Docket #8
CD-CPC-2026-00023
Development Plan – M1-5

5019 Raytown Road

April 15, 2026

City Planning Commission

D5 NORTHWEST ELEVATION
1/8" = 1'-0"

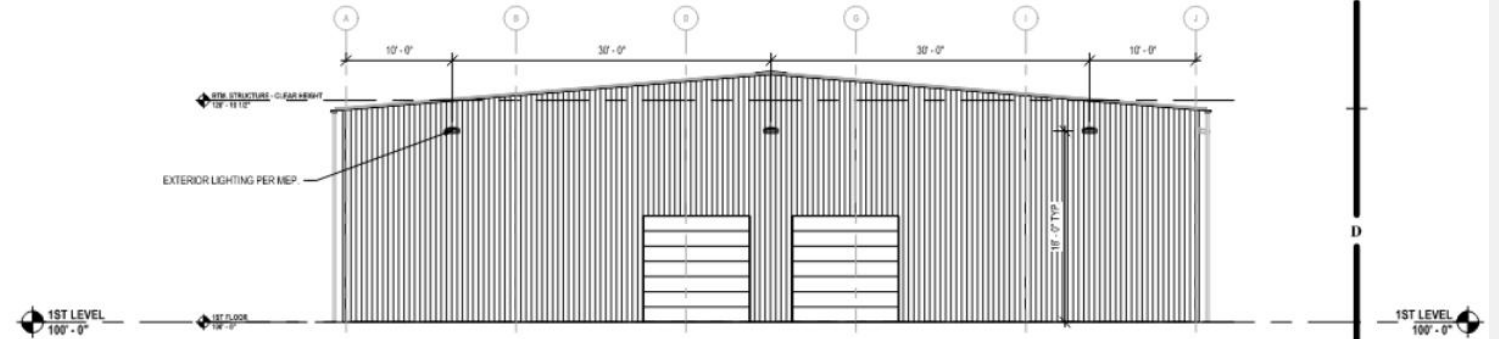
- 15. The applicant shall revise the building elevations to apply high quality building materials including but not limited to brick, stone, cast stone, finished concrete, stucco (not EIFS), metal (not sheet or pan style), or cement board to the front facade of the proposed building facing Raytown Road to increase alignment with design guidelines in the area plan and KC Spirit Playbook and Raytown Road's identified Image Street status. This shall be completed prior to ordinance request.

- 16. The applicant shall revise elevations to add eye-level windows with two-way transparency, clerestory windows, or material changes to the front facade of the proposed building facing Raytown Road to better align with the Well-Designed City goal of the KC Spirit Playbook. Denote on the elevations the material type and location on the elevation drawings. This shall be completed prior to ordinance request.
